Work Order ID 125196

Item Name: Replacement Skidtube, Low Gear with Run-on Landing Fits LH or RH

DRAWING NO. D3804	TITLE SKIDTUBE ASSEMBLIES, 206A/B	REV. A	DART AEROSPACE LTD ENGINEERING ORDER		D.E.O. NO. D3804-A-1	SHEET NO. SHEET 1 OF 1	SCALE NTS
DRAWN <i>CP</i>	CHECKED <i>A.P.</i>	MFG. APPR. <i>[Signature]</i>	APPROVED <i>[Signature]</i>		DE APPR. <i>[Signature]</i>		
DATE 12.10.12	DATE 12.10.22	DATE 12.10.22	DATE 12.10.22		DATE 12.10.22

CHANGE C'BORED WELDED CROSSBOLT SPACERS TO SWAGED SPACERS

DETAIL B

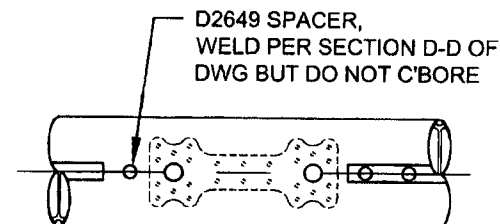
WAS:

19	20	D2649	CROSS BOLT SPACER
----	----	-------	-------------------

ADD SECTION H-H BELOW, WHICH IS THE SAME SECTION VIEW AS SECTION D-D OF DWG.
C'BORED HOLES ARE **NOW SWAGED** PER SECTION H-H BELOW. FOR THE Ø0.375 HOLE THAT IS NOT C'BORED, WELD PER SECTION D-D OF DWG (SEE AMENDED DETAIL B FOR REFERENCE).
